### **Addendum No. 3**

**Date:** October 27, 2017  
**City Project:** 14-25, "East Monte Vista Avenue Rehabilitation"

ALLEY APPROACH

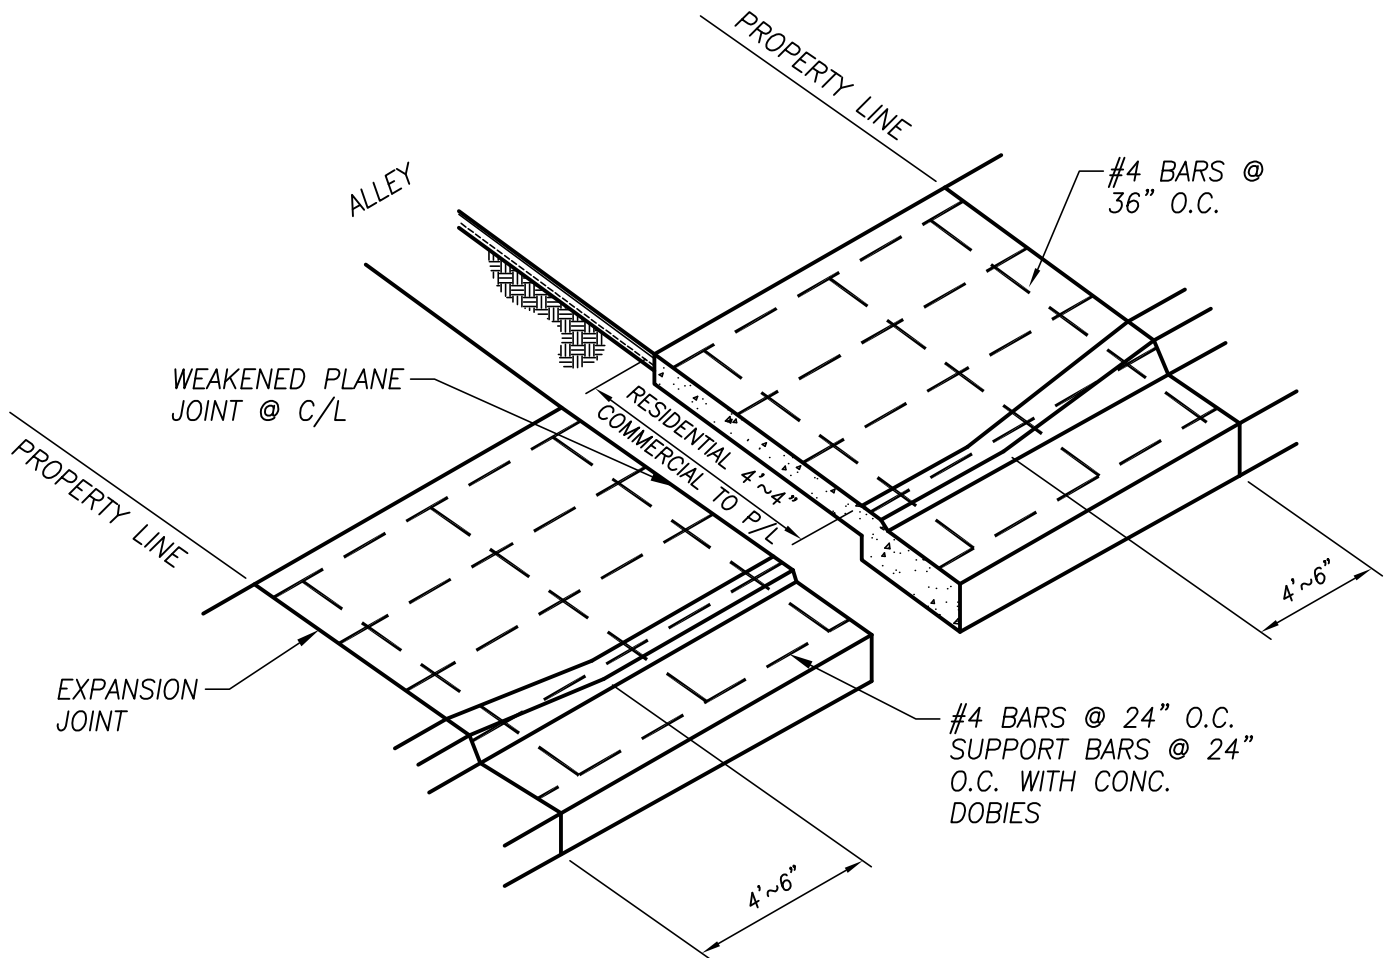
The change to Sheet 10 from the addendum no. 1 version made with this addendum no. 2 is changing the text for the note pointing to the driveway west of Radcliffe Way "INSTALL ALLEY APPROACH PER CITY STANDARD DWG. NO. C-7." The city standard detail c-7 is included as an attachment to this addendum.
